Proposed Northern Access Road at Macquarie Point

Cycling South has the following comments to make on the proposed plans.

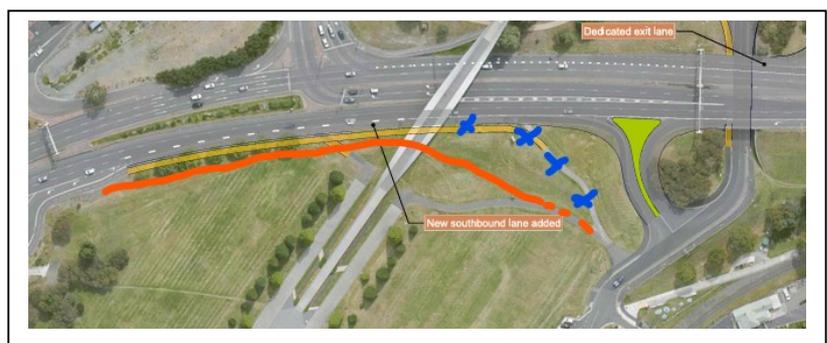
Intercity Cycleway to Tasman Hwy Path – the connecting path needs to balance gradients with directness and a wide sweeping bend following the contours is preferable to windy switchbacks.
